Applicability

This Technical Note applies to TB8100 power management units (PMUs) fitted with an AC module (product code TBA30AXX-XXXX), and with the serial number 18002512 or lower.

Introduction

There is a possibility that a component on the AC converter PCB may fail when the PMU is powered up. This Technical Note explains why this might happen, and describes the modifications needed to prevent it from happening.

Figure 2 Replacing Q304 and R336

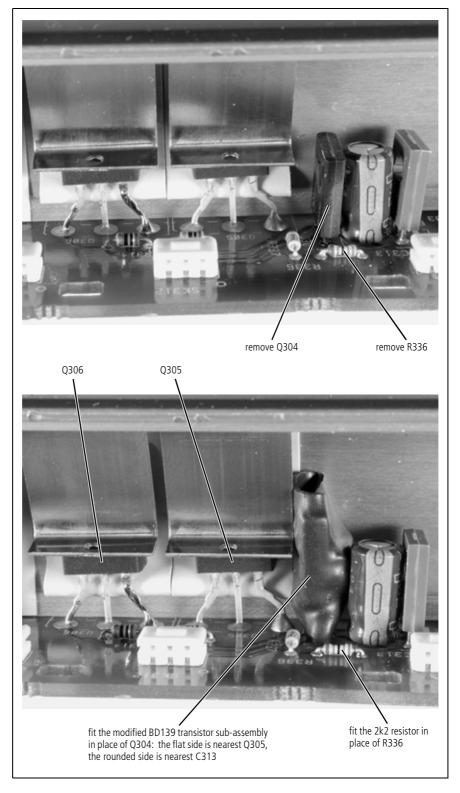
A modified BD139 transistor sub-assembly has been prepared, which is fitted in place of the original BD139 (Q304). This sub-assembly consists of a BD139 transistor, a BC327 transistor, a 47Ω resistor, and a 220Ω resistor. R336 is also changed from 15k to 2k2. Refer to Figure 5 for details of the modifications to the circuit.

- 3. Remove Q304 and R336 from the AC converter PCB, as shown in Figure 2.
- 4. Fit the modified BD139 transistor sub-assembly in place of Q304, with the correct orientation, as shown in Figure 2.

- 5. Fit the 2k2 resistor in place of R336, as shown in Figure 2.
- 6. Refit the PFC control card, as shown in Figure 3.
 - a. Insert the top of the card into the groove in the heatsink O.
 - b. Align the plugs on the card with their matching sockets on the AC converter PCB.
 - c. Press the card down firmly at each end ② so that each plug fits correctly into its matching socket. There should be an audible "click" when each plug is fully inserted.

Figure 5 Modifications to the Circuit

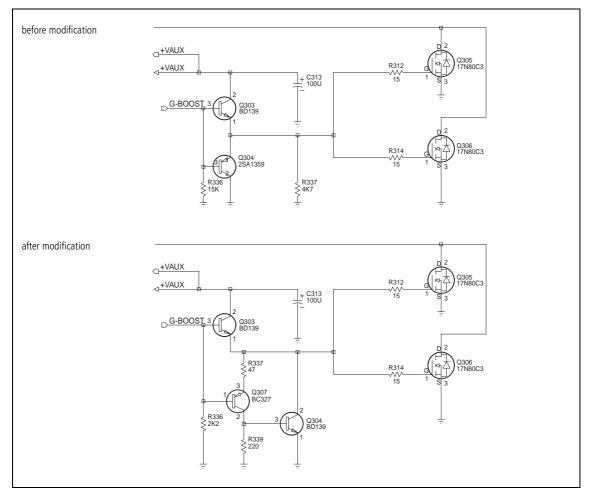
Figure 5 below shows the AC converter circuit before and after these modifications.
